Site Instruction

Project Name: AQUAVISTA - Bayside

SI No.: E 034

Title: Revision – PV System

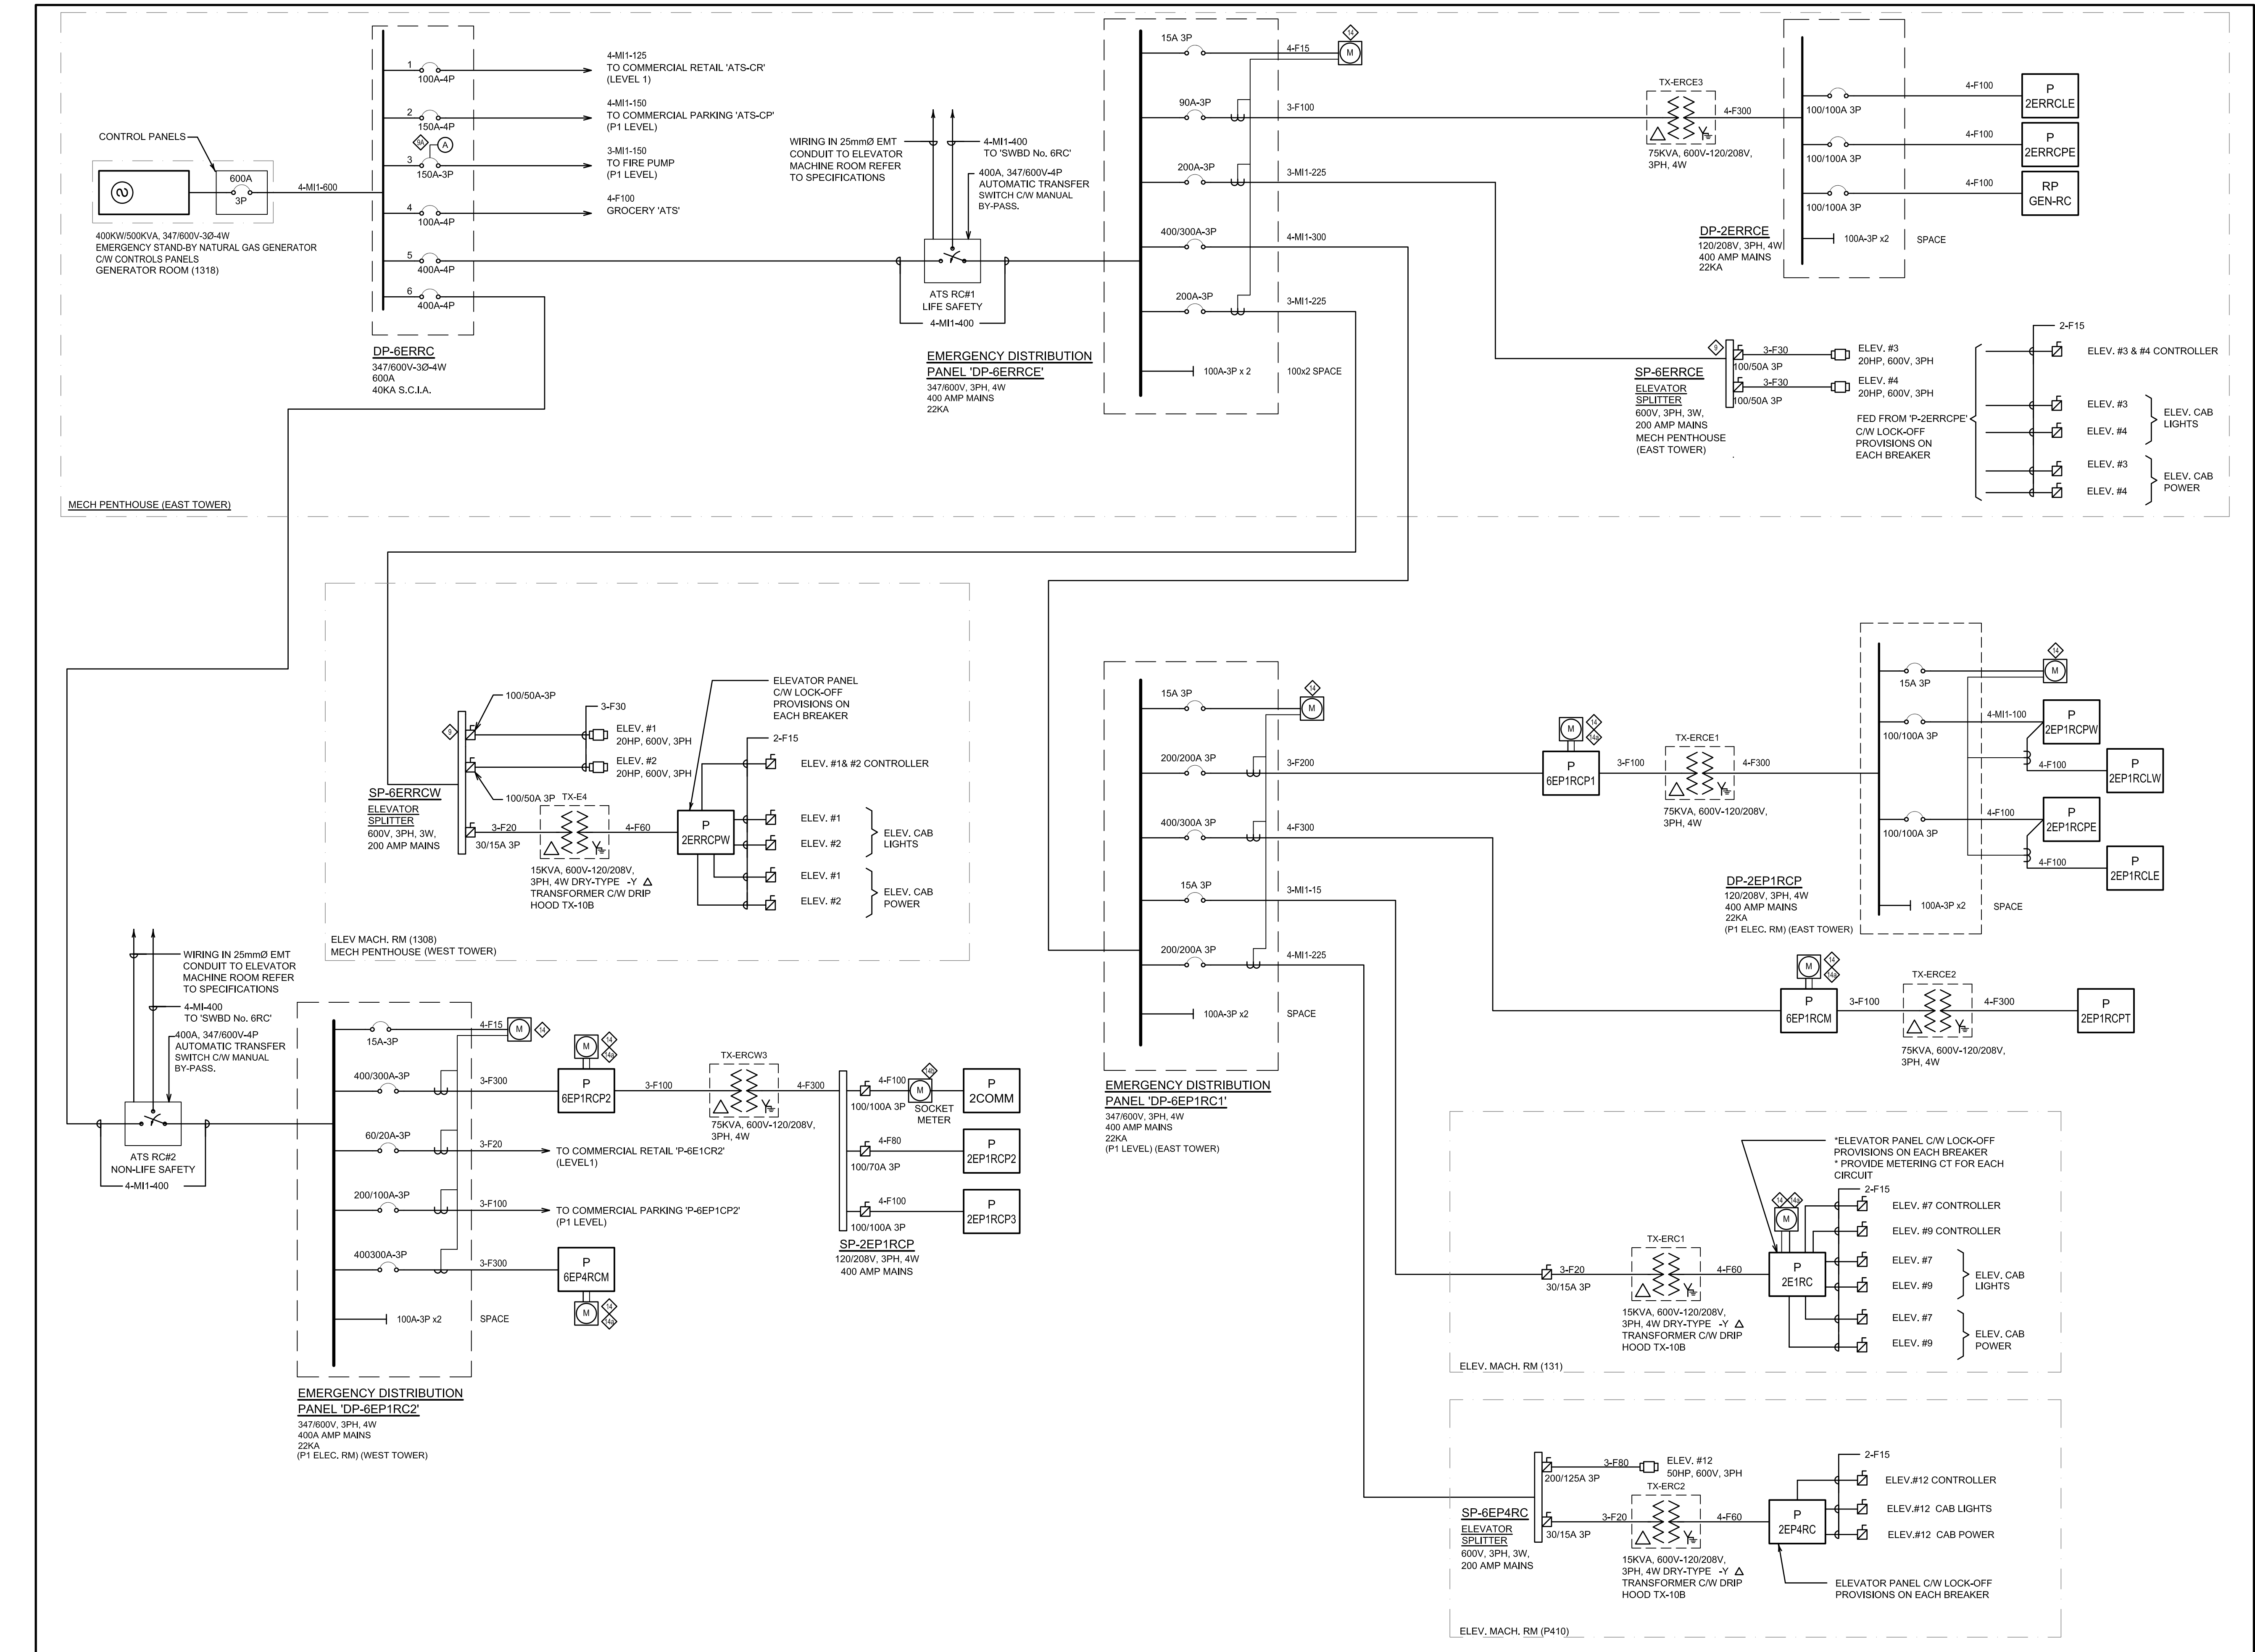
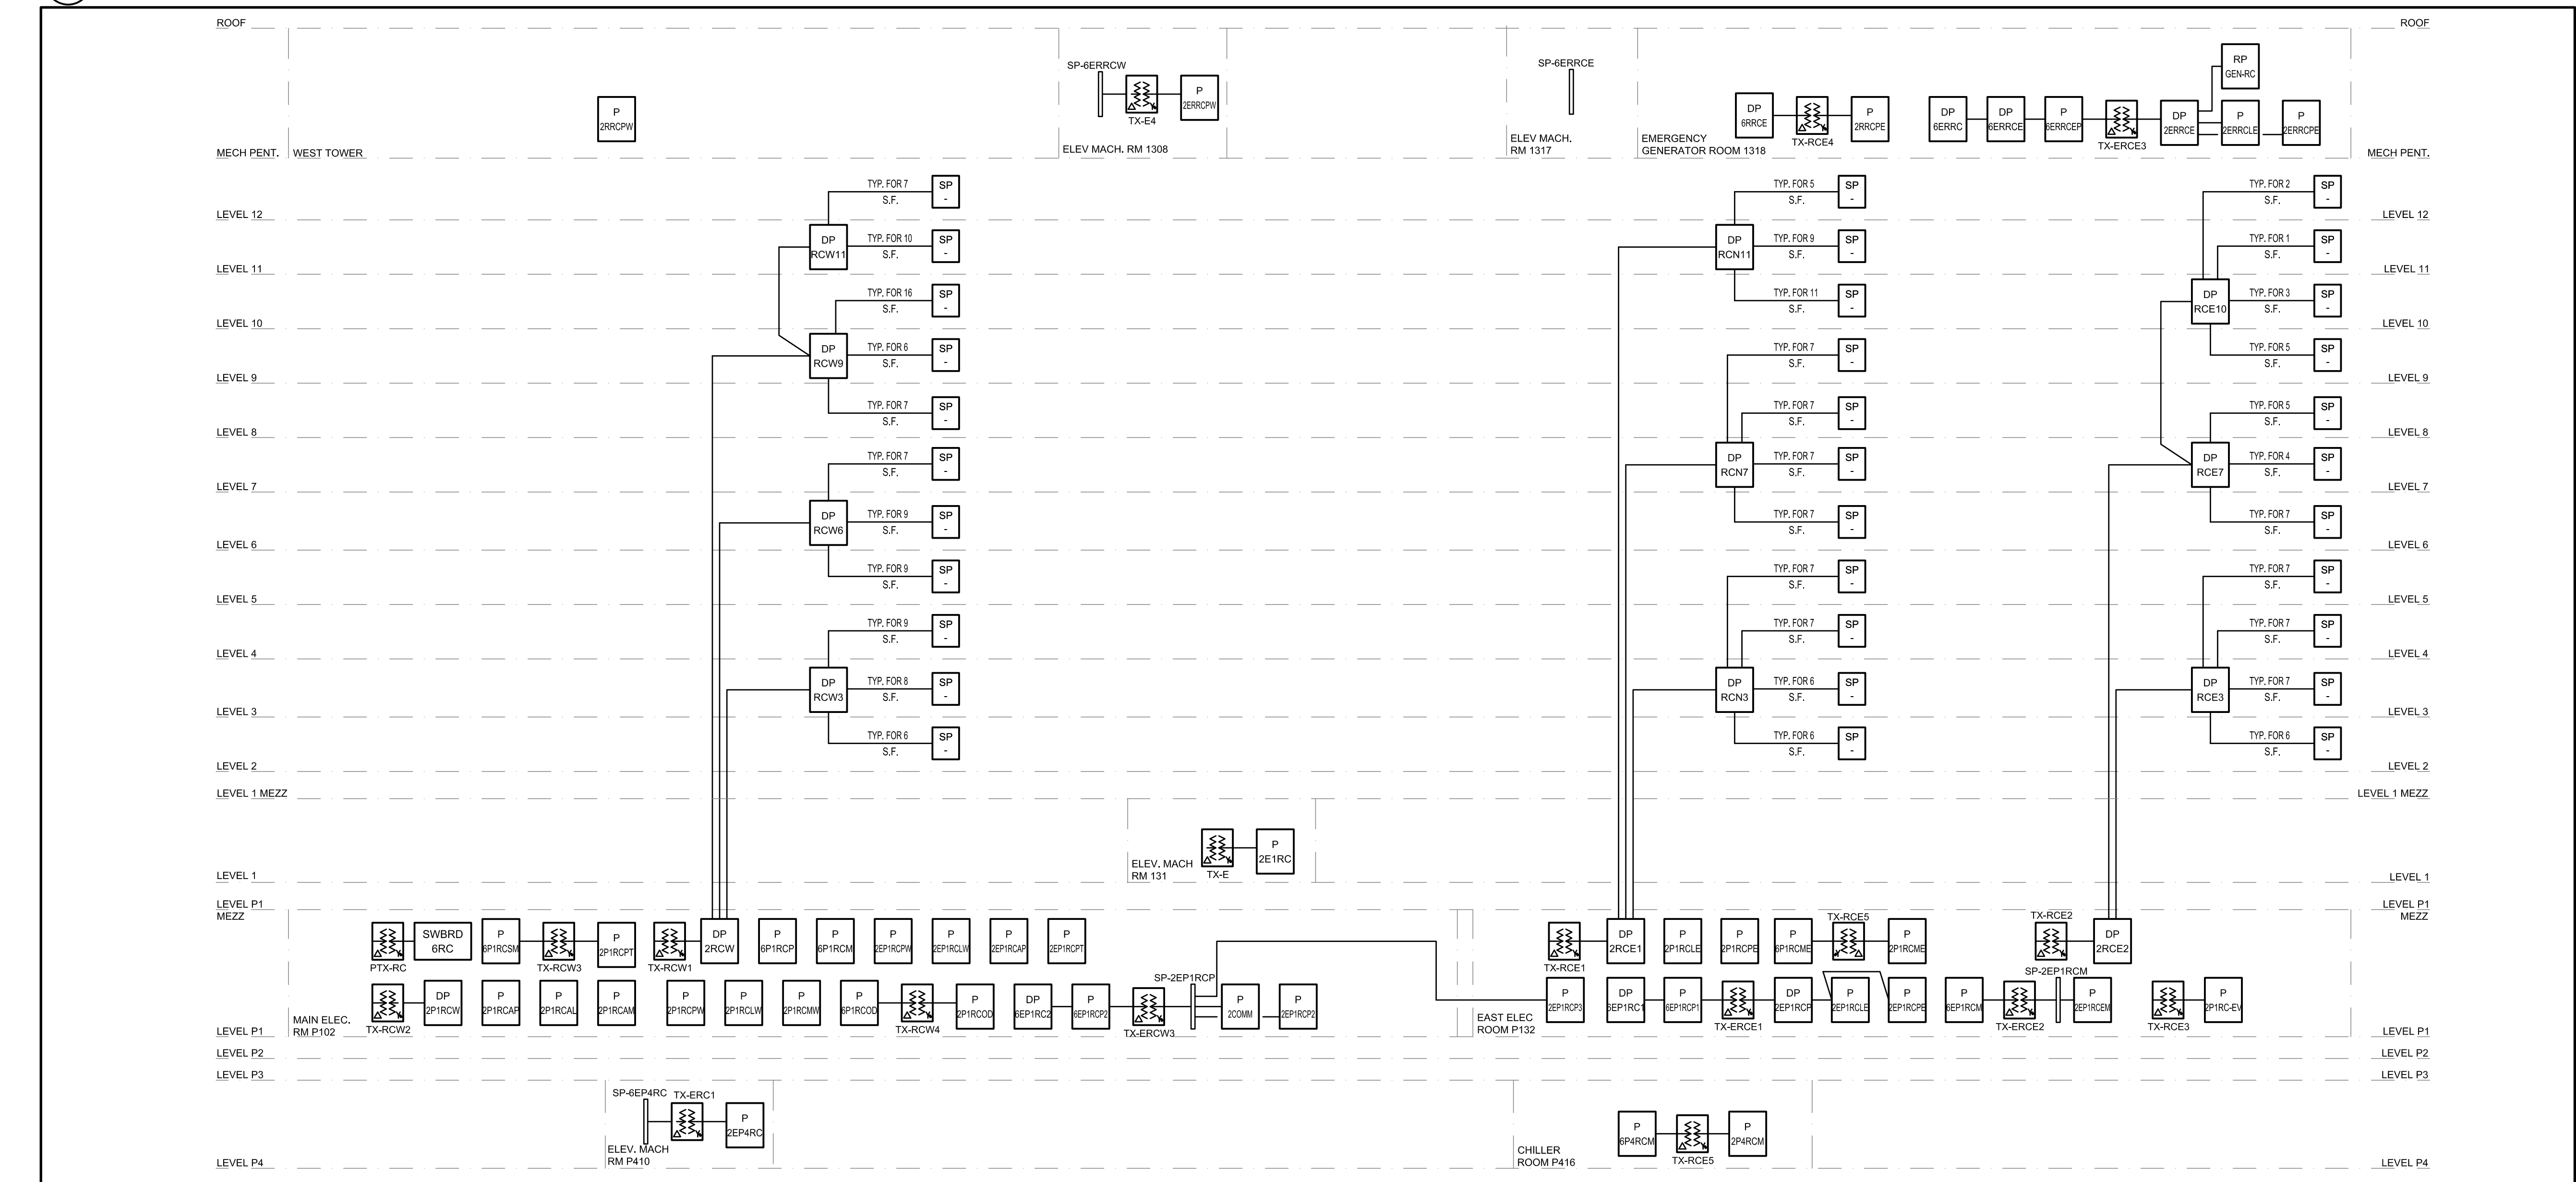
Drawing No.	Drawing Issued	Items
E3-01-RC	Yes	Add 50A, 3P breaker on panel DP-6RRCE and 60A, 3P utility isolation disconnect for the PV Inverter connection as shown on the drawing.
